BURLINGTON DEVELOPMENT REVIEW BOARD

Tuesday May 3, 2016

BURLINGTON DEVELOPMENT REVIEW BOARD Tuesday May 3, 2016, 5:00 PM Contois Auditorium, City Hall, 149 Church Street, Burlington, VT AMENDED AGENDA

Subdivision Plan
Main Street
Landing Company

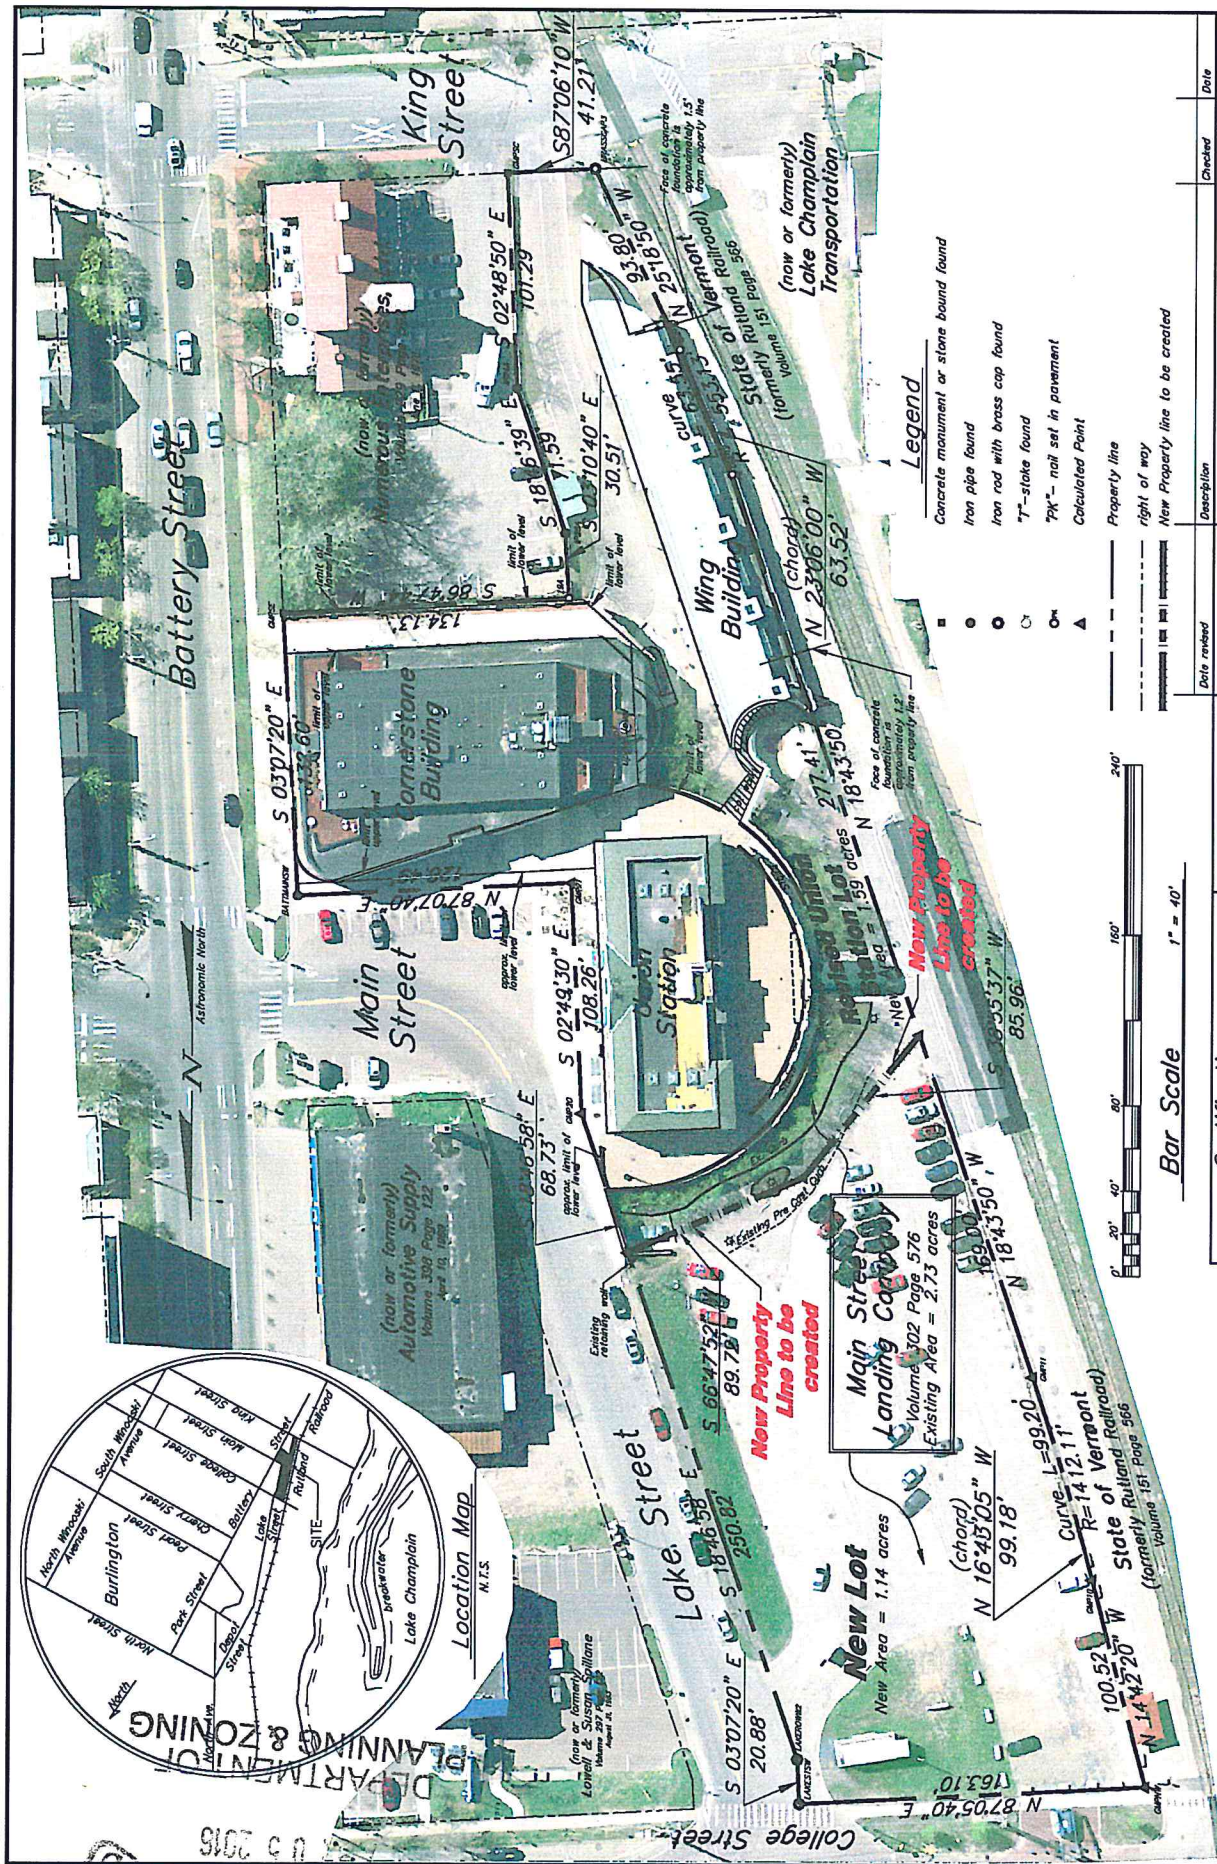
I have no concerns over this lot subdivision without construction. Evaluated for fire department access and water supply, I see no changes to the property itself other than the property line adjustment/creation. Any future construction will be subject to the applicable codes and standards in effect at that future time.

100-102 NORTH UNION SITE PLAN

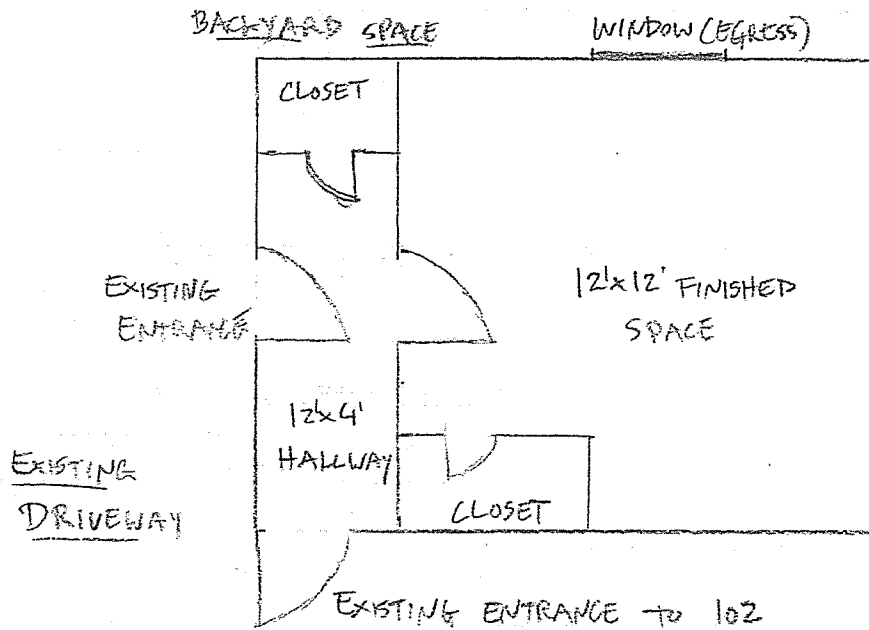
The proposed parking plan on the submitted site plan does not meet the required 5' minimum side yard setback. **Adverse finding.**

2. Scaled plan appears inaccurate (site plan scales lot width as 61'; tax maps identify lot width as 56.32'). No survey was provided to confirm parking adequacy or required setbacks on the parcel. **Adverse finding.**

The applicant provided a site plan drawn 1"=10'; however there appear to be inaccuracies. The lot per tax and assessor's records is 56.32' wide while the site plan illustrates the width in excess of 60'. A concrete pad that surrounds the north side of the house is not illustrated, nor are the utility meters with protective bollards. On-site measurements define lot width between the concrete walk and the first (westerly) bollard as 11.8'; the width measurement between the walk and the 2nd bollard as 12.25'; not the 20' illustrated.

The bollard-protected utility meter restricts full width parking on the south of the driveway, the bollard and chain on the north. The location of the northerly property boundary is not known. These measurements are inconsistent with the submitted site plan, which was presented as "existing driveway/parking." **Adverse finding.**

The site plan prepared by the applicant indicates a building footprint of 2110 sf and an "existing driveway" of 70' x 20'. The total area (excluding walkways) is 3510 sf, or 66.71% lot coverage. This exceeds allowable base coverage for the zoning district of 40%.

The parking area/driveway is illustrated on the site plan as up to the northerly (side yard) property line. There is not sufficient evidence that this is a preexisting nonconformity, and therefore presents an encroachment into a required sideyard setback. The applicant did not present a survey to support the accuracy of his plan. **Adverse finding for coverage and setback compliance.**

The site plan submitted by the applicant omits a setback from the side (north) property line, and therefore presents an encroachment into a required side yard setback. **Adverse finding.**

Aerial Photo 2003 from Google Earth, shows two cars parked tandem. Prior to fence

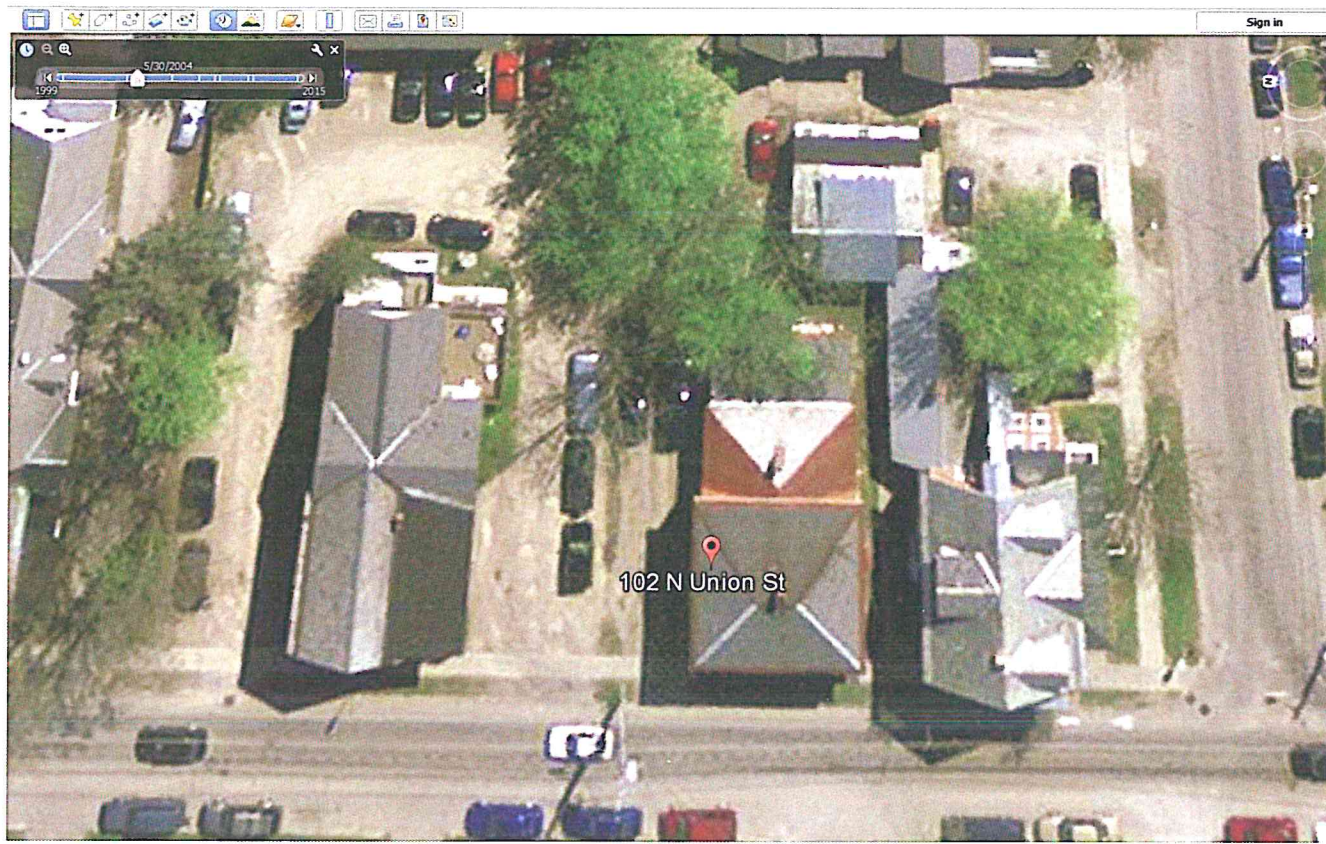
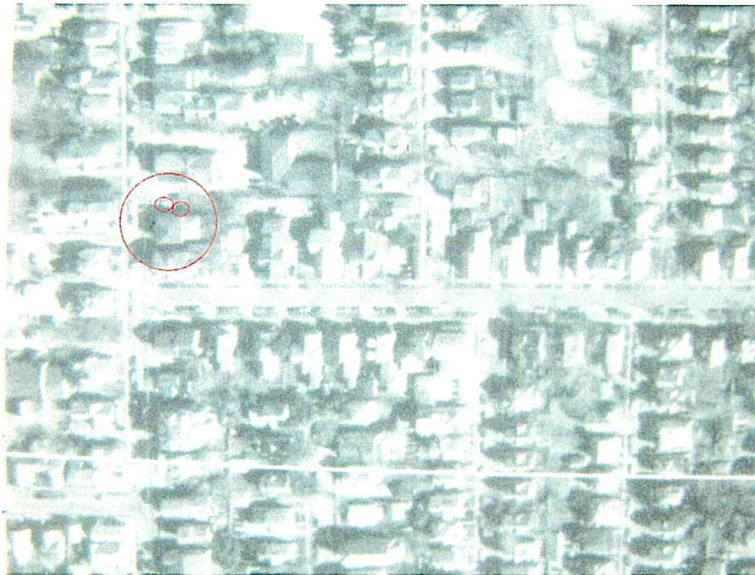
Per this standard, the applicant must add a parking space for each room added until the full parking requirement is met (a total of 4 parking spaces.) The submitted site plan suggests that the existing pattern of parking is paired tandem parking spaces. Although this would meet the required number of spaces, the plan encroaches into a required side yard setback. Applicant's assertion that the encroachment is a preexisting nonconformity is not supported in photodocumentation. **Adverse finding.**

There is no approved site plan that includes parking definition on file for this property. From photographs, parking appears to have been haphazard, with evidence that vehicles were scattered in the rear or parking over the northerly property line. The most recent permit issued was for a bollard-and-chain fence next to the driveway, with notations on the plan:

Provided by applicant. 2000. Note annotation of cars.

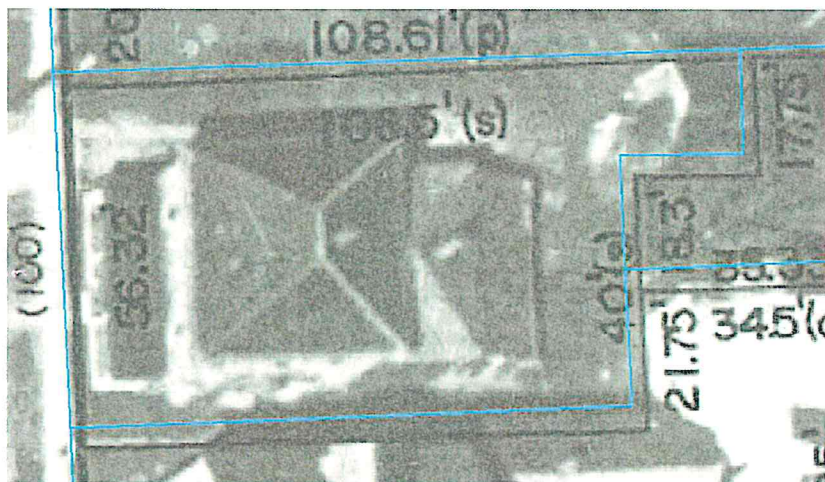
The applicant submitted a detail copy of a 2000 aerial photograph where he asserts adequate parking is represented. The photograph does illustrate vehicles in the driveway, but they are “off-set” from each other; staggered within the access drive and therefore not representative of the parking plan submitted as pre-existing.
